PLANNING NMA-CHANGE LIST		
ID	Proposed Changes to plans that are 'Non Material'	Reason for 'Amendment'
A	Changes to Common stair towards compliance for general access where a clear landing needs to be provided and to accommodate smoke control. Circulation area and internal doorways to stairs rearranged to adapt corridor aisle. Stairs, structurally stacked for construction leading towards a vertical smoke shaft that opens at roof level with rationalised communal entrance/exit. Lift shaft changed to allow for minimum required headroom height (Overhead height). Rearrangement in plan due to the above visible on the Northeast facade. Window openings, adapted to suit mentioned changes/rearrangement.	Compliance towards Building Regulations, Part-K-Protection from falling, collision and impact and Part-B-Fire safety
B	Changes to Communal lifts and stairs towards compliance for firefighting where a firefighting shaft is required as the building is over 18m and to accommodate smoke control and building services. Circulation area internal doorway to stairs and clear landing for lifts rearranged to adapt corridor aisle. Stairs, structurally stacked for construction leading towards a vertical s

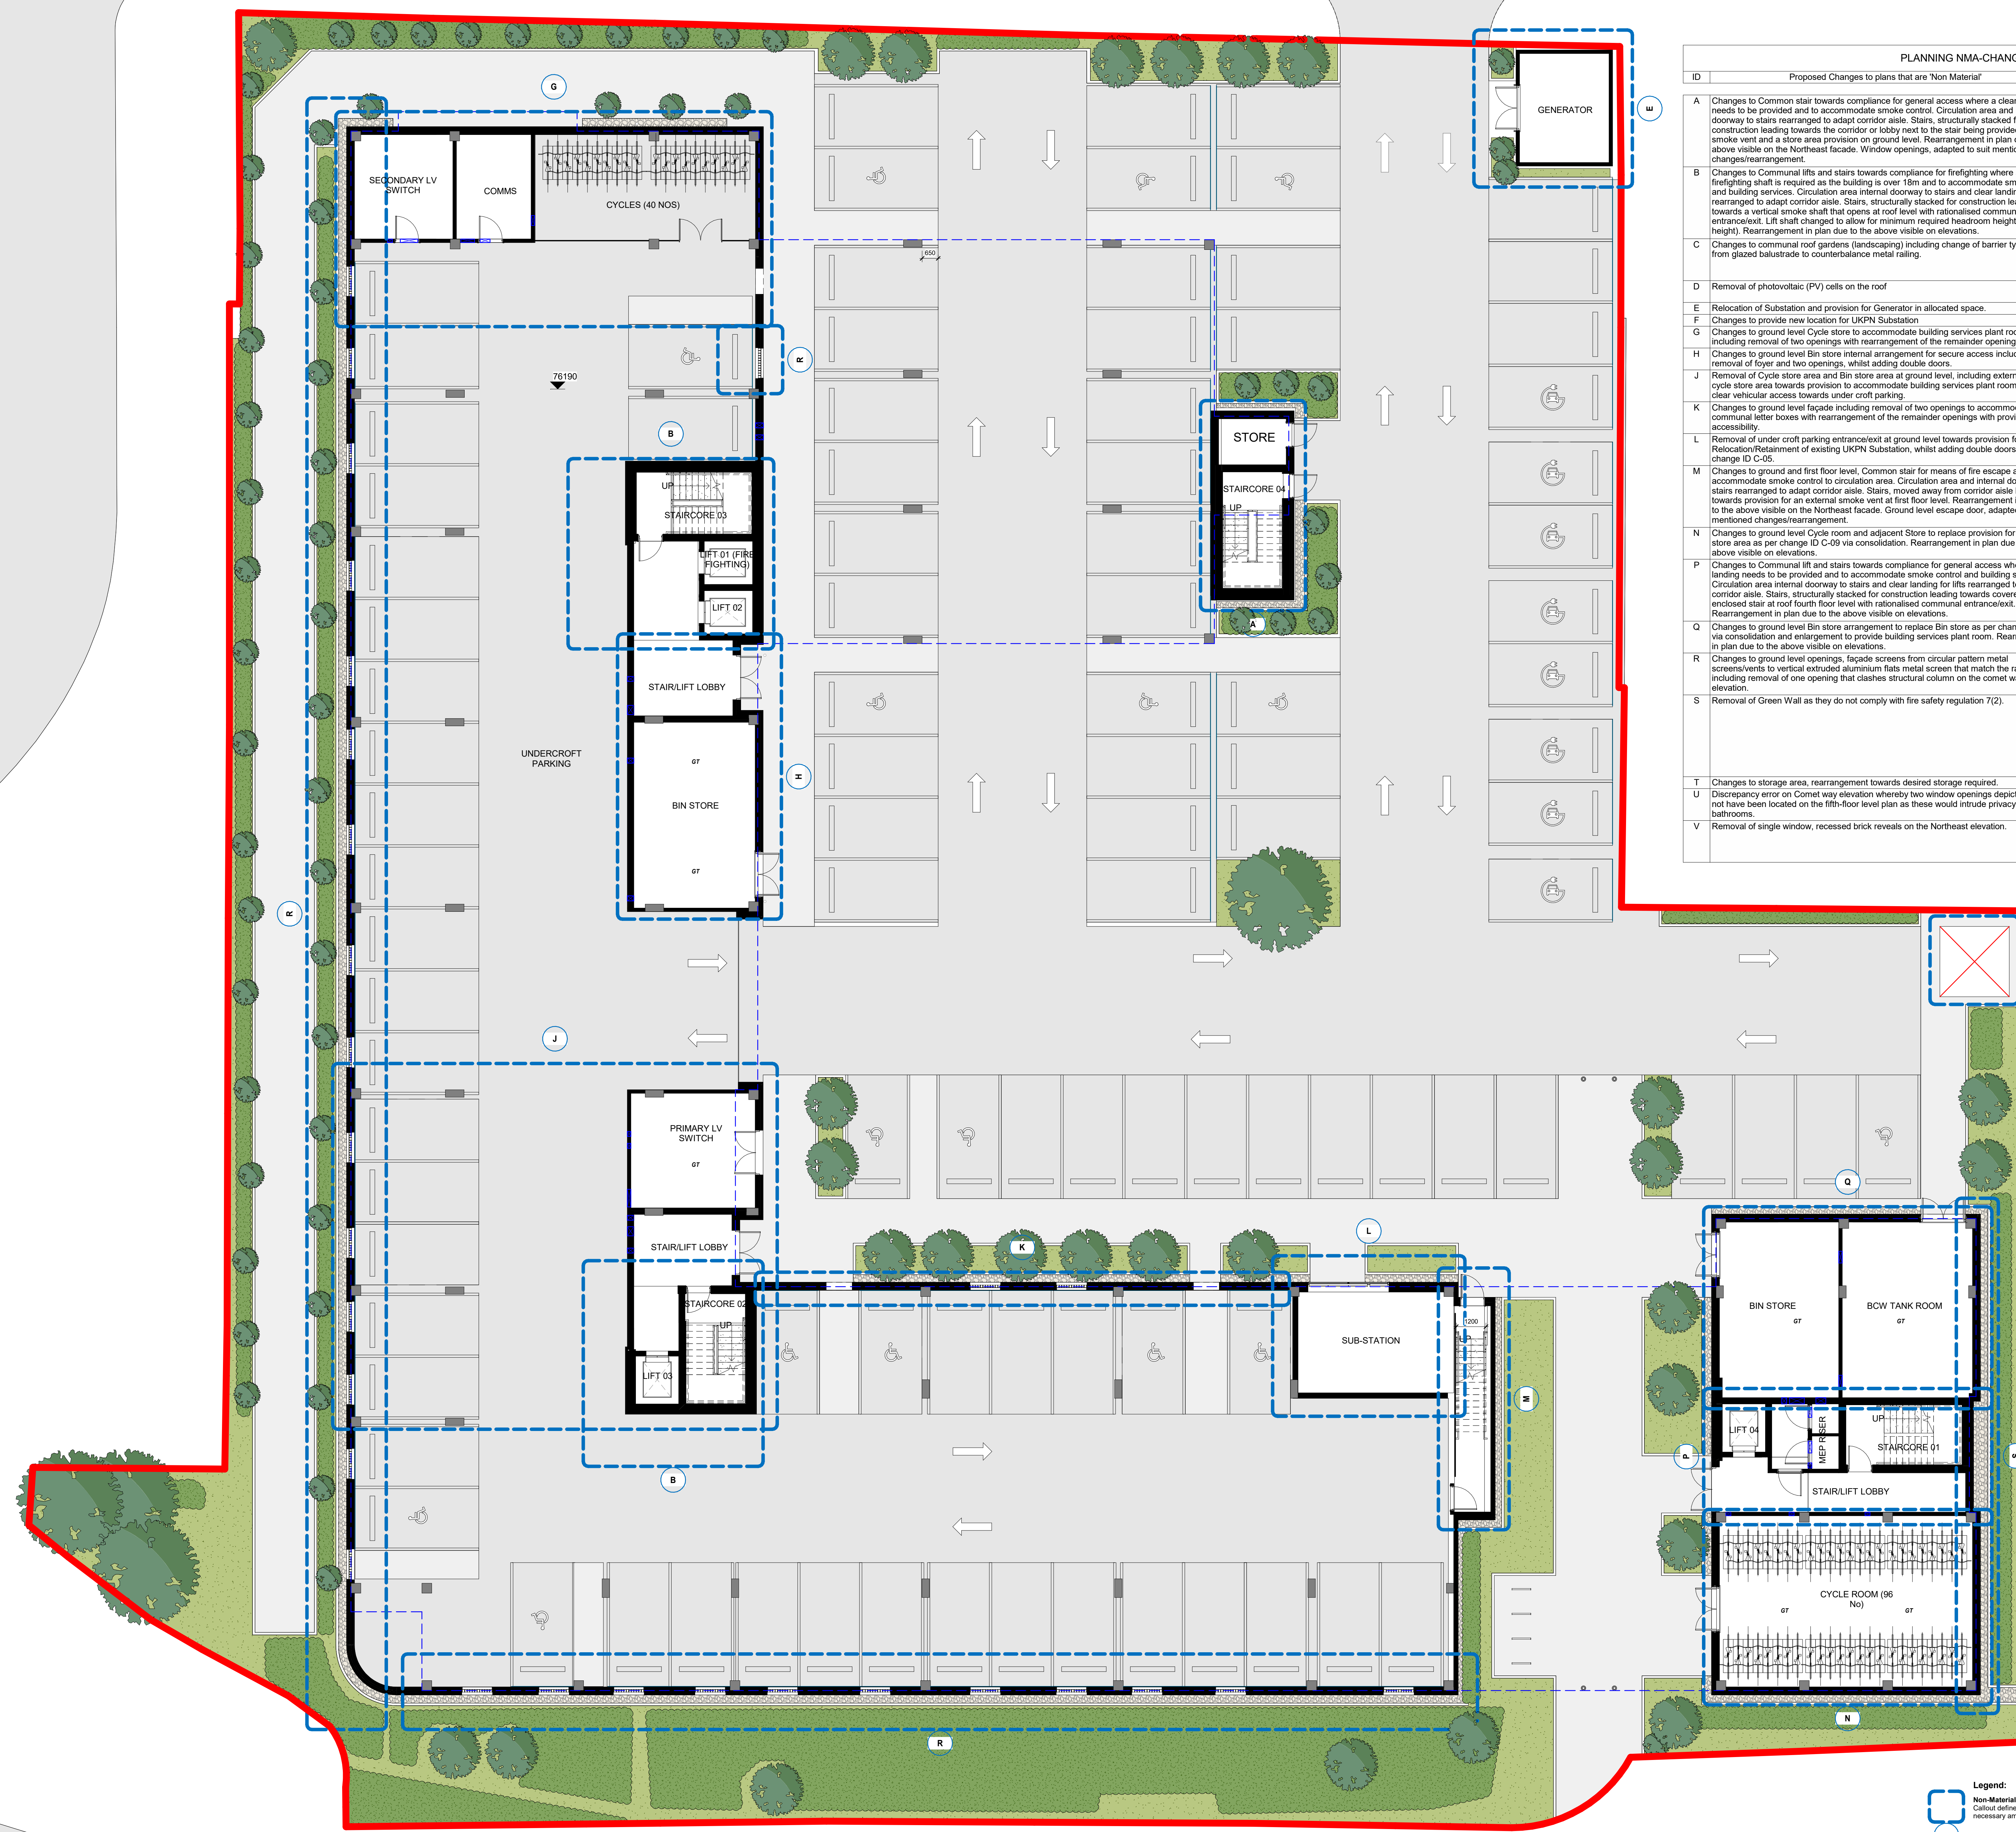
C	Changes to communal roof gardens (landscaping) including change of barrier type (railing) from glazed balustrade to counterbalance metal railing.	To contribute positively towards biodiversity via balance of soft and hard landscaping schemes including provisions for bird and bat boxes, whilst maintaining overall uniformity for railing type.
D	Removal of photovoltaic (PV) cells on the roof	PV was not required as Part L requirement was met using Exhaust Air Heat Pumps.
E	Relocation of Substation and provision for Generator in allocated space.	Provision for separate secluded area for generator
F	Changes to provide new location for UKPN Substation	Provision for future relocation for UKPN Substation
G	Changes to ground level Cycle store to accommodate building services plant rooms including removal of two openings with rearrangement of the remainder openings.	Provision towards Building Services, Secondary LV switch room and Comms room.

H	Changes to ground level Bin store internal arrangement for secure access including removal of foyer and two openings, whilst adding double doors.	Provision towards secure access for Bin store
J	Removal of Cycle store area and Bin store area at ground level, including external door in cycle store area towards provision to accommodate building services plant room including clear vehicular access towards undercroft parking.	Provision towards Building Services, Primary LV switch room and vehicular access towards undercroft parking.
K	Changes to ground level facade including removal of two openings to accommodate communal letter boxes with rearrangement of the remainder openings with provision for accessibility.	Provision towards communal letter boxes
L	Removal of undercroft parking entrance/exit at ground level towards provision for Relocation/Retention of existing UKPN Substation, whilst adding double doors as per change ID C-05.	Provision towards single point of entry/exit for undercroft parking and towards relocation/retention of existing UKPN Substation mentioned in change ID-E.

M	Changes to ground and first floor level, Common stair for means of fire escape and to accommodate smoke control to circulation area. Circulation area and internal doorway to stairs rearranged to adapt corridor aisle. Stairs, moved away from corridor aisle leading towards provision for an external smoke vent at first floor level. Rearrangement in plan due to the above visible on the Northeast facade. Ground level escape door, adapted to suit mentioned changes/rearrangement.	Compliance towards Building Regulations, Part-B-Fire safety.
N	Changes to ground level Cycle room and adjacent Store to replace provision for Cycle store area as per change ID C-09 via consolidation. Rearrangement in plan due to the above visible on elevations.	Provision towards replacement of removed cycle store mentioned in change ID-J.
P	Changes to Communal lift and stairs towards compliance for general access where a clear landing needs to be provided and to accommodate smoke control and building services. Circulation area internal doorway to stairs and clear landing for lifts rearranged to adapt corridor aisle. Stairs, structurally stacked for construction leading towards covered and enclosed stair at roof fourth floor level with rationalised communal entrance/exit. Rearrangement in plan due to the above visible on elevations.	Compliance towards Building Regulations, Part-K-Protection from falling, collision and impact, Part-B-Fire safety and Provision for stair enclosed/walkway that is directly covered.

Q	Changes to ground level Bin store arrangement to replace Bin store as per change ID-C-09 via consolidation and enlargement to provide building services plant room. Rearrangement in plan due to the above visible on elevations.	Provision towards replacement of removed Bin store mentioned in change ID-J and provision for BCW Tank room.
R	Changes to ground level openings, facade screens from circular pattern metal screens/vents to vertical extruded aluminium flats metal screen that match the railing type, including removal of one opening that clashes structural column on the comet way elevation.	To maintaining overall architectural uniformity and structural framing.
S	Removal of Green Wall as they do not comply with fire safety regulation 7(2).	Regulation 7(2), requires all residential blocks with top storey heights over 18m to have all materials which become part of an external wall or specified attachment (e.g., balconies) to achieve class A2-s1, d0 or class A1, except for materials which are exempt as per regulation 7(3). Additionally, membranes used as part of external wall construction above ground should achieve a minimum of class B-s3, d0.

T	Changes to storage area, rearrangement towards desired storage required.	Provision towards desired storage required.
U	Discrepancy error on Comet way elevation whereby two window openings depicted would not have been located on the fifth-floor level plan as these would intrude privacy for the bedrooms.	Discrepancy error
V	Removal of single window, recessed brick reveals on the Northeast elevation.	The recessed brick reveals is between two windows mostly on all elevations, whilst single windows mostly do not have such a detail. To maintain architectural uniformity, detail removed.
